RESPONSE TO OBJECTOR TOWN PLANNERS' SUBMISSIONS DATED 04/04/19: AMENDED DA 272/19 - 49 BEACH RD, BATEMANS BAY

Figure 1: Approved building envelopes - SCC

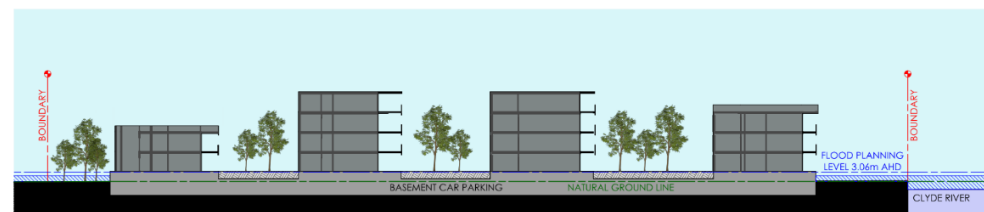
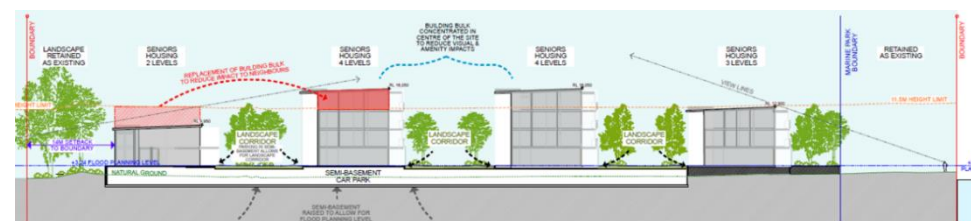
- Having regard to the LEC decision in *Waterbrook Bayview Pty Ltd v Northern Beaches Council [2019] NSWLEC 1112*, the proposed development is not 'of the kind' certified by the SCC as the proposed development:
 - is of an increased height, bulk and scale to that which was certified by the SCC; and
 - does not comply with the height development standard whereas the scheme submitted with the SCC showed a compliant building height.

- The SCC application sought approval for buildings varying in height between 2 storeys and 4 storeys. Following submission of the SCC application in February 2018, the applicant issued a letter to the DPE on 15 May 2018 relating to the site's flood risk and flood affectation. The letter included advice obtained from Council regarding the flood planning level applicable to the site and the need to raise the proposed buildings above this level. An amended plan showing the 2 to 4 storey buildings above the 3.06m flood planning level was included with the letter (see Figure 1). The DPE issued the SCC on 10 August 2018 in the knowledge of the building heights proposed.
- As shown in the extracted figures below, the bulk and scale of the building envelopes approved by the SCC have not increased under the amended scheme.
